SUBJECT: QUAD CITIES NUCLEAR POWER STATION, UNITS 1 AND 2 – STAFF
ASSESSMENT OF FLOOD HAZARD INTEGRATED ASSESSMENT
(EPID NO. L-2018-JLD-0008)

STAFF ASSESSMENT BY THE OFFICE OF NUCLEAR REACTOR REGULATION
RELATED TO THE INTEGRATED ASSESSMENT
FOR QUAD CITIES NUCLEAR POWER STATION, UNITS 1 AND 2
AS A RESULT OF THE REEVALUATED FLOODING HAZARD
NEAR-TERM TASK FORCE RECOMMENDATION 2.1 - FLOODING
EPID NO. L-2018-JLD-0008

Figure 3.2-1 Differences in Digital Elevation Model used in FLO-2D due to site changes

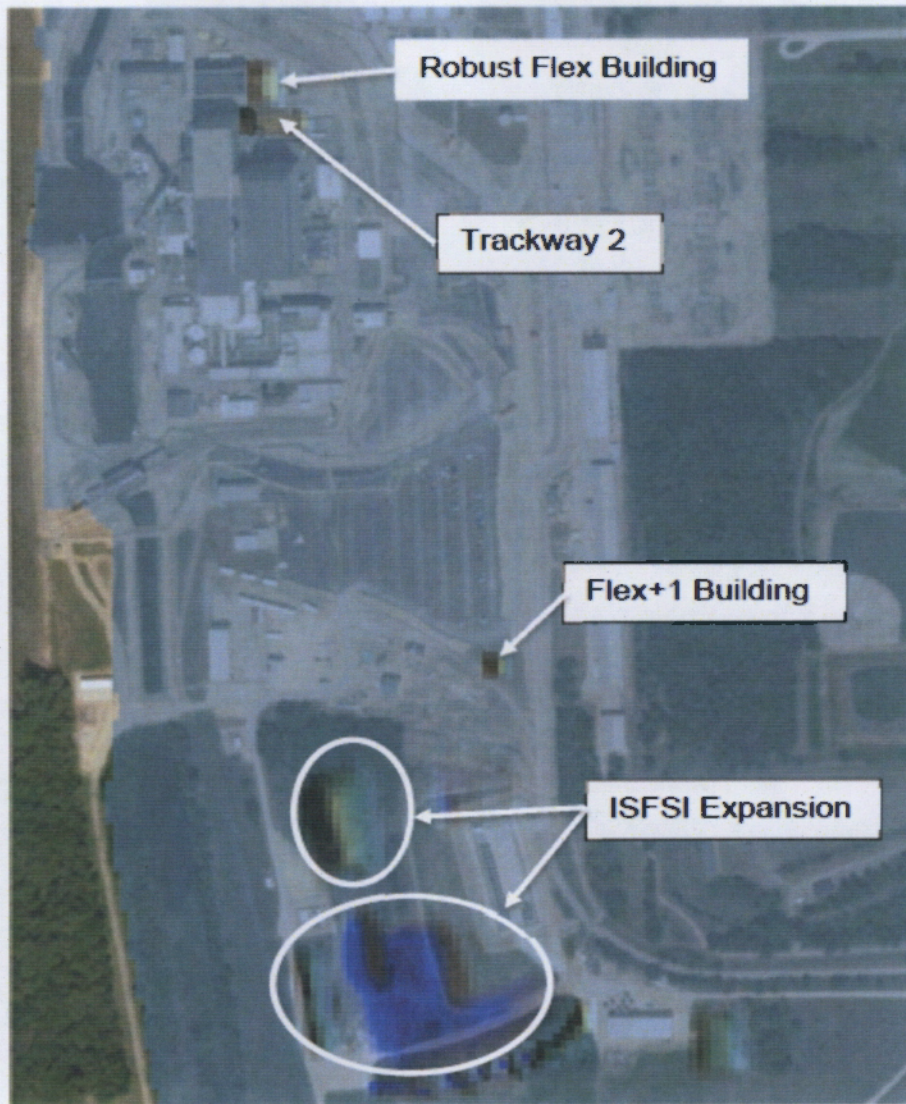
The NRC staff reviewed the changes made to the licensee's FLO-2D model by comparing the previous and current versions of the Digital Elevation Model (DEM) used in the licensee's FLO-2D model (Figure 3.2-1). The NRC staff found that changes made by the licensee to the DEM are consistent with the description provided by the licensee in their IA. Additionally, the NRC staff verified that the rooftop parapets on the RB and Turbine Building (TB) were properly incorporated into the licensee's FLO-2D model.
